CERTIFICATE OF APPROPRIATENESS APPLICATION FORM

Address 1118 Tulane St. Houston, TX 77008
 Historic District / Landmark West-Houston Heights HCAD# 020200000026
 Subdivision Houston Heights Lot 26 + 27 Block 204

- **Subject of Proposal:**
Amendment of the Certificate of Appropriateness for 1118 Tulane St.

ROBINSON RESIDENCE
1118 TULANE
HOUSTON, TX. 77008

A2.0.1

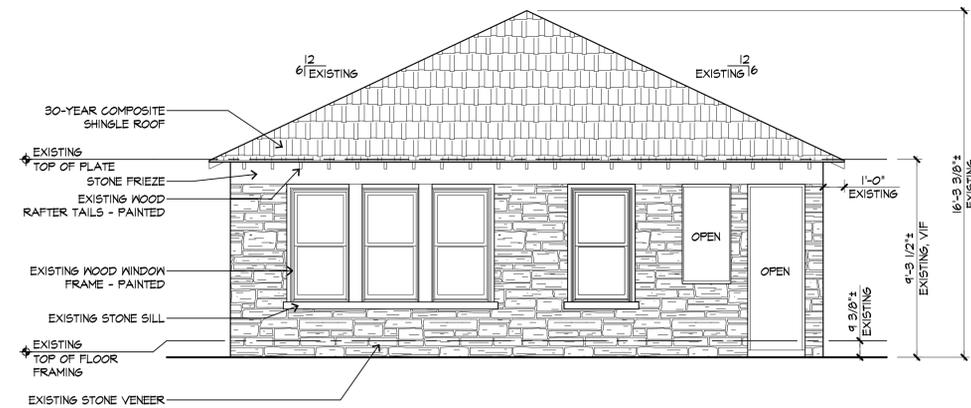
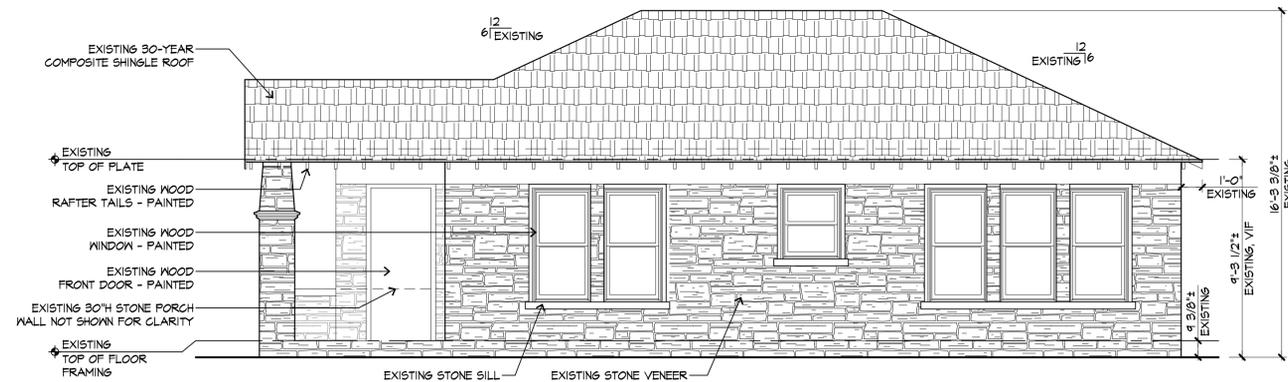
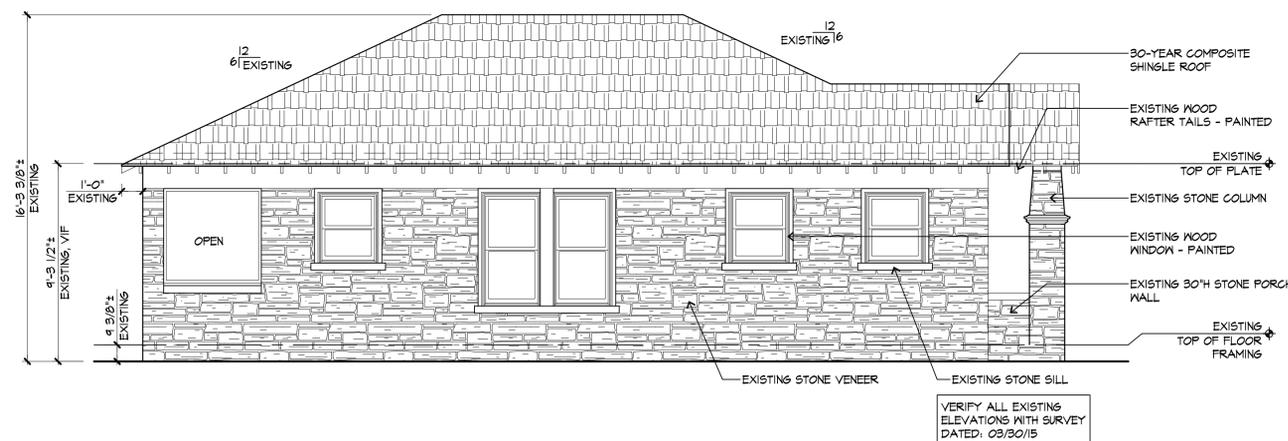
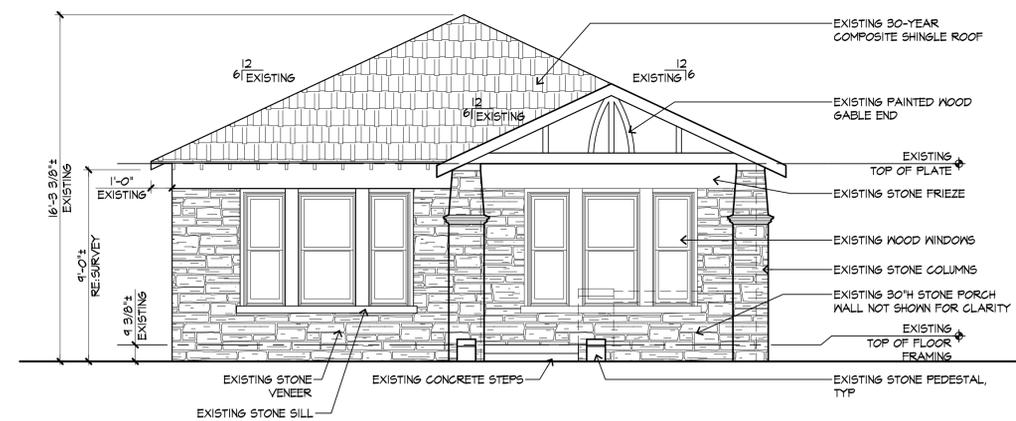
3. There is inadequate ventilation under the existing structure and we would like to increase the number of vents matching the existing from 5 to 12 to increase the air flow in the crawl space. Increasing the size of the retrofitted crawlspace vents on the original structure would allow for better airflow as well as access under the house for repairs and maintenance; Re: A2.0.1, A2.1.1 & A2.2.1

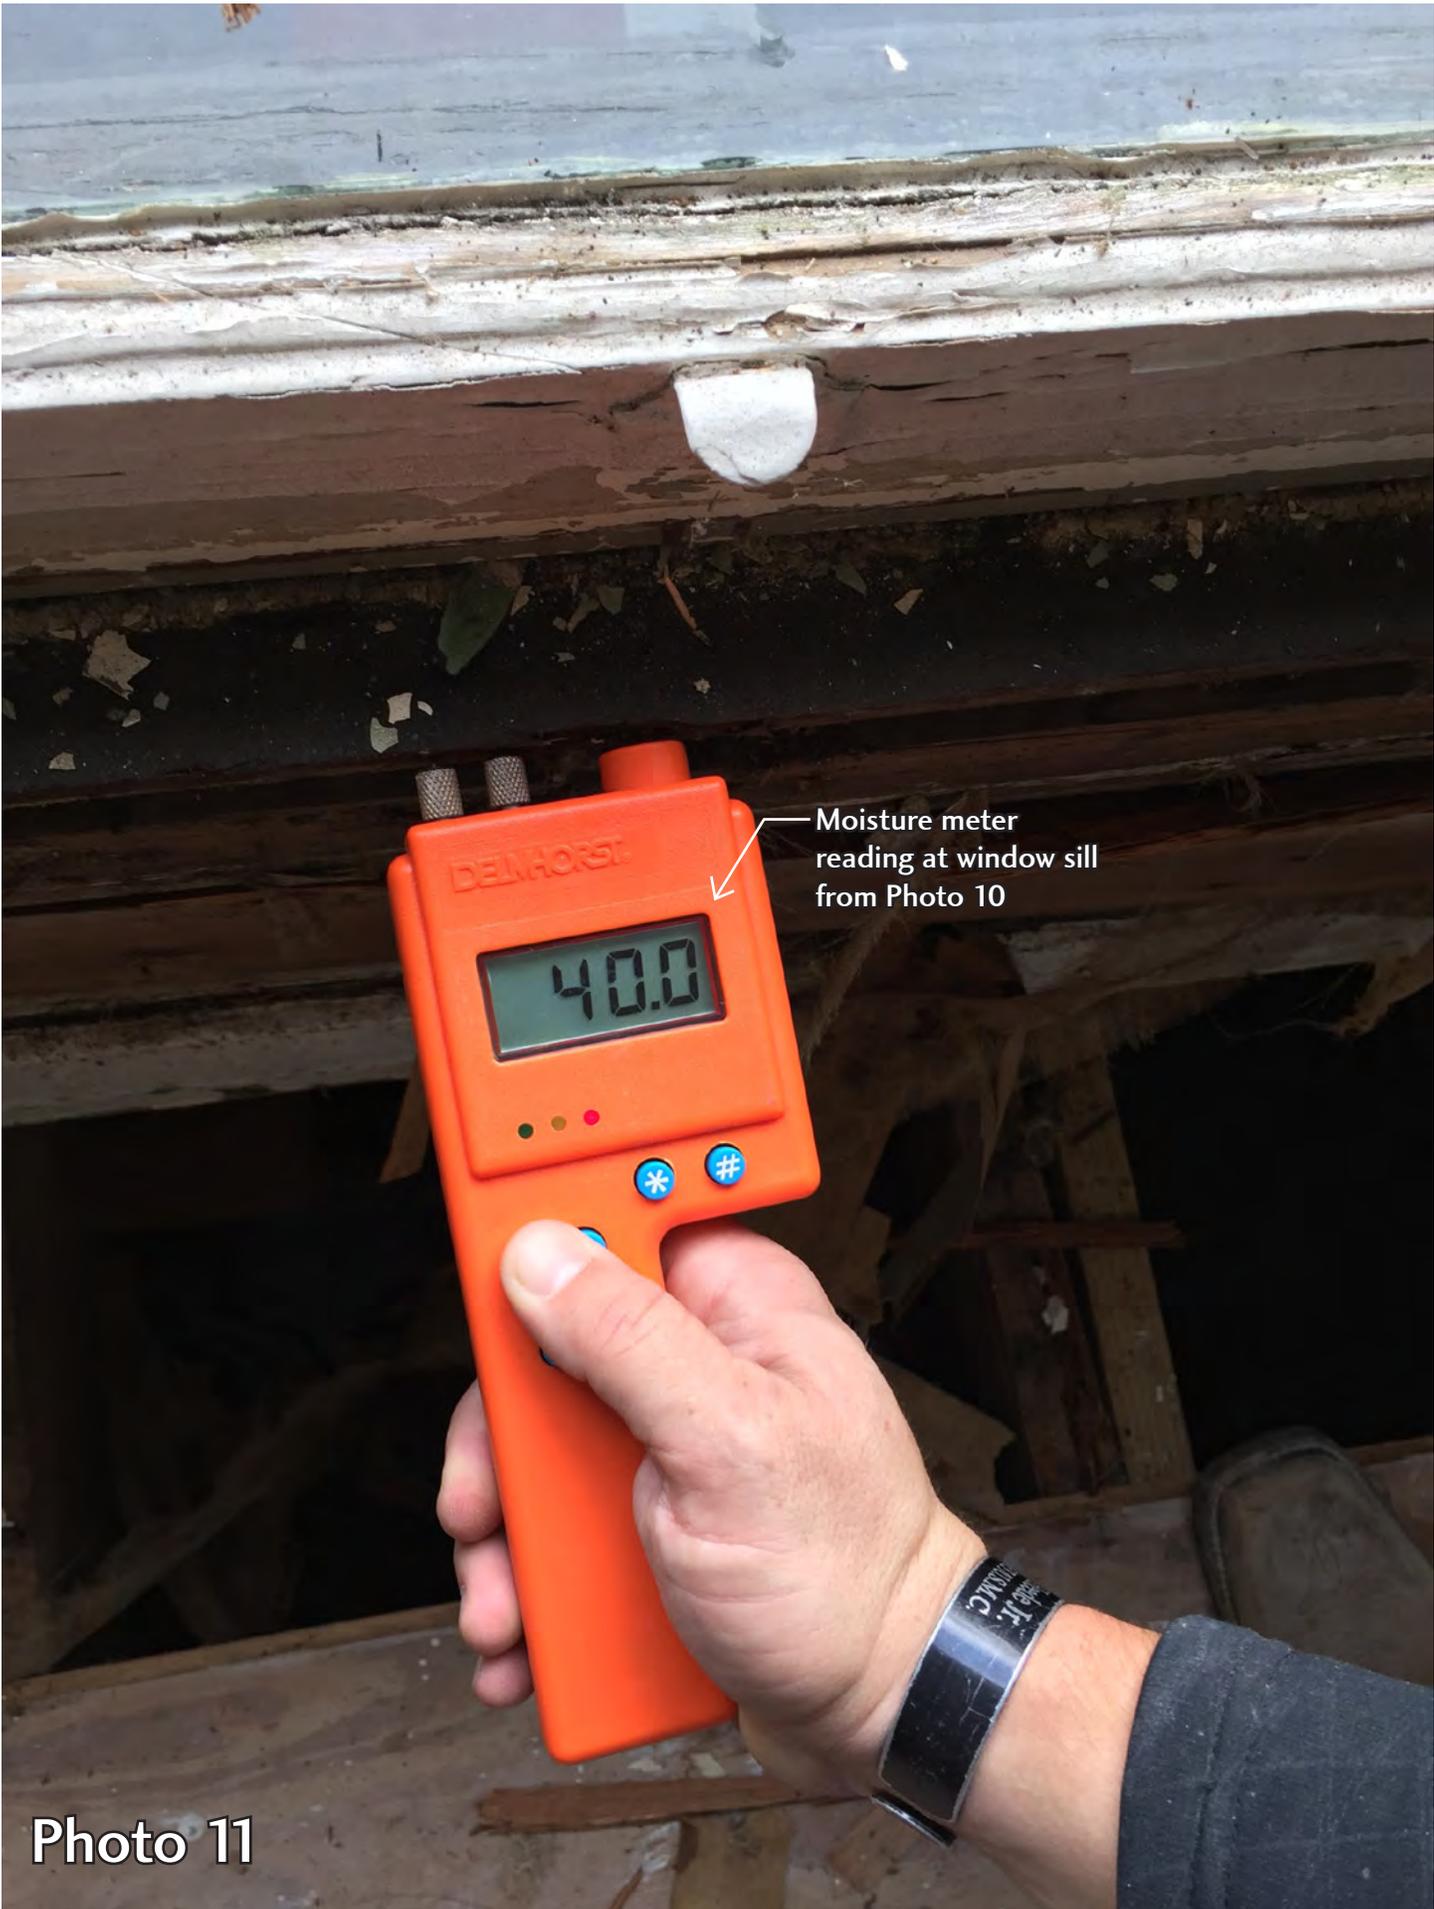
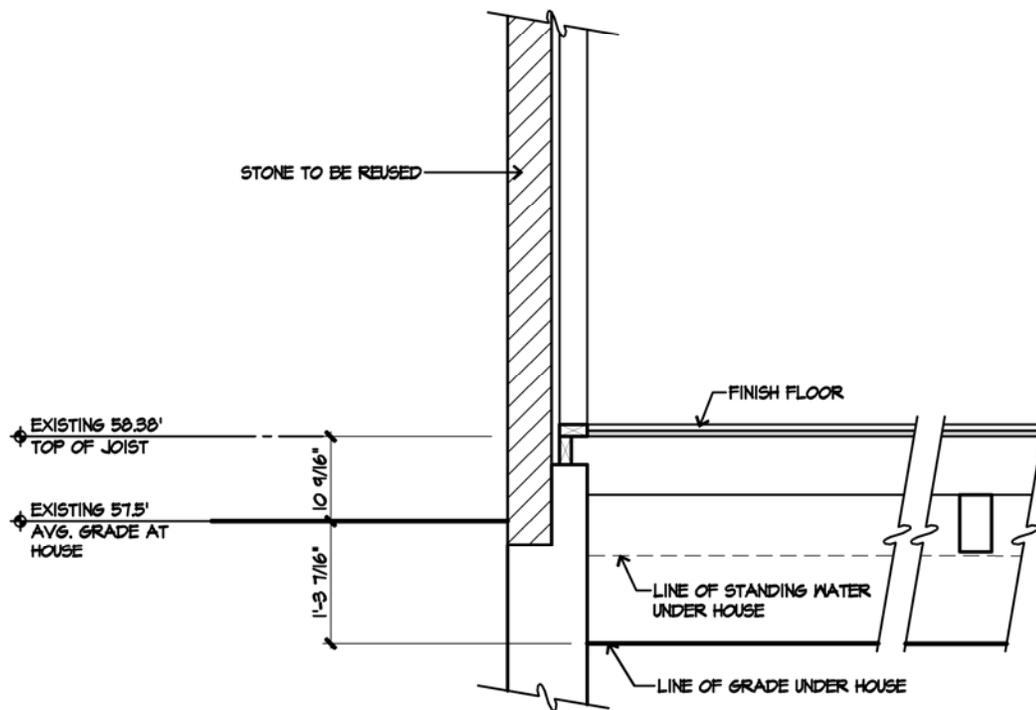
4. A majority of the sill plates and studs are rotten and termite damaged and the roof framing is deflected and in poor condition. There are logistics, safety and liability concerns to supporting the existing roof framing while the wall framing is replaced, therefore, we would like permission to rebuild the structure of the building as a replica and re-clad with the historic stone façade. This will deliver the best building to the client while preserving the historic nature of the neighborhood; Re: Photo Exhibits

SD-001

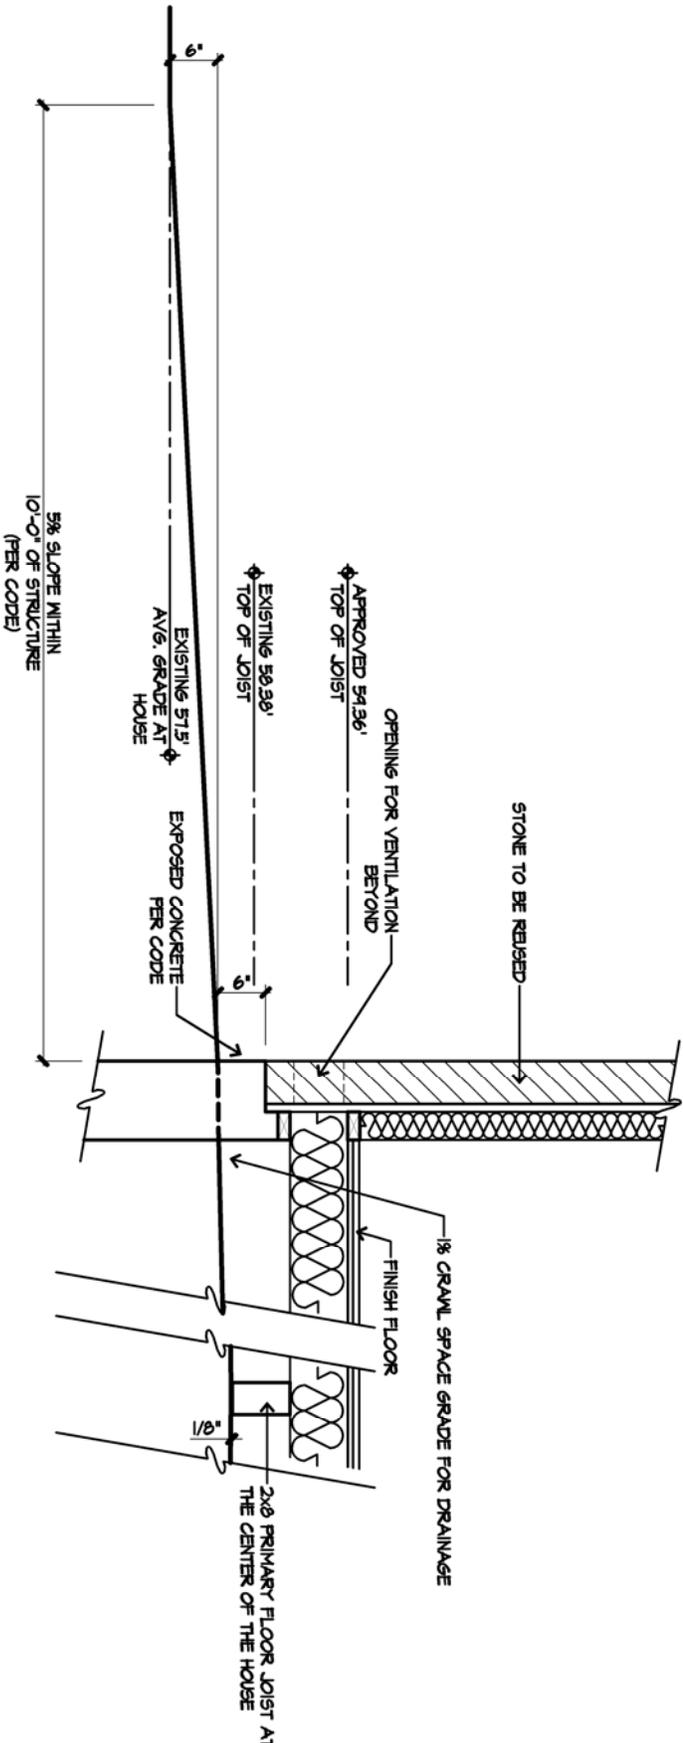
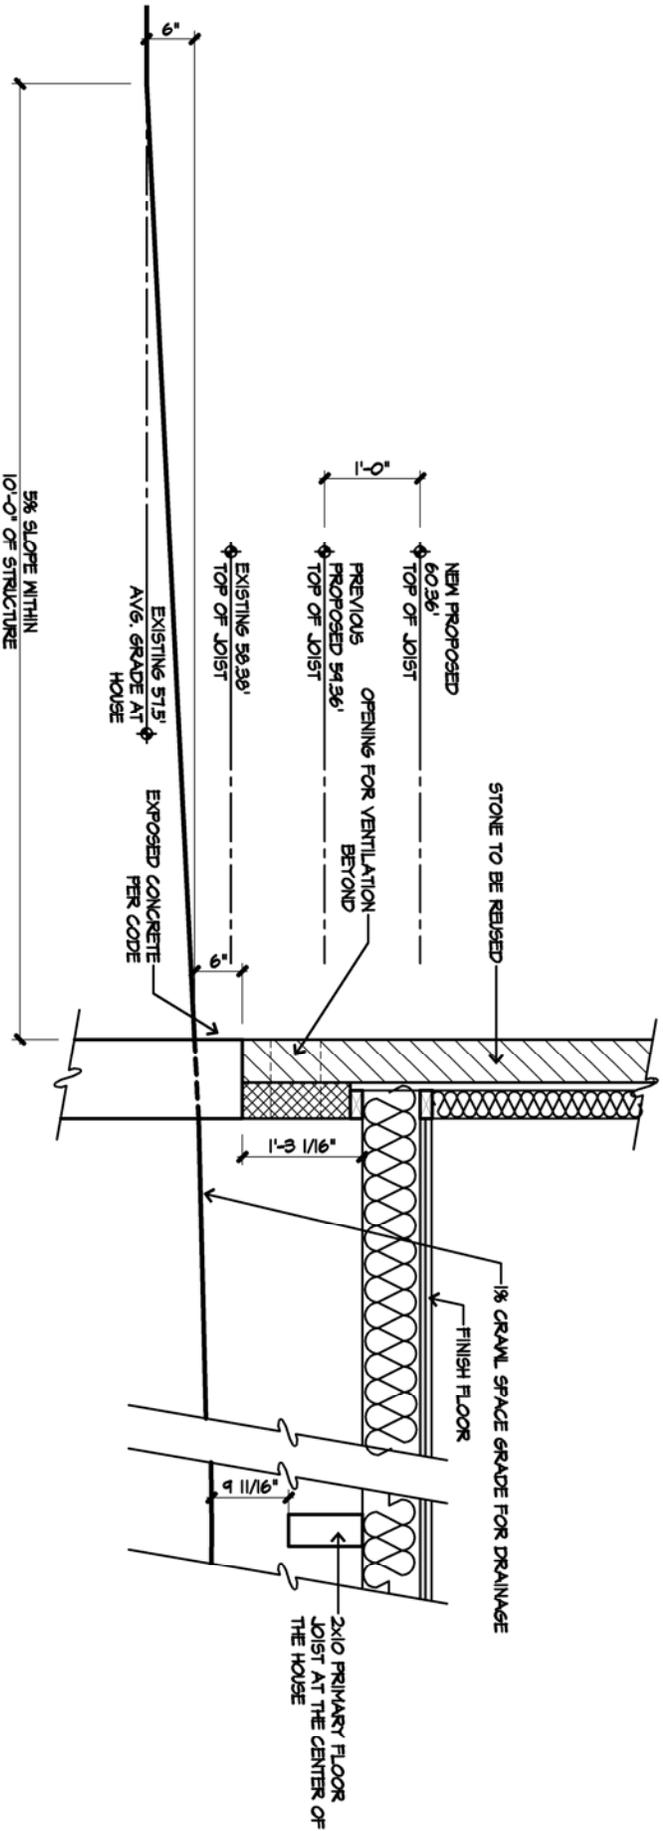
1. The existing slope of the lot is insufficient to get proper drainage under the house while conforming the city code regulating drainage away from structures and exposed concrete above grade. Those code requirements add 6" to the grade at the house and 6" to the height of the slab above grade. This will require the structure to be raised an additional 12" to compensate for these additional requirements; Re: SD001-003
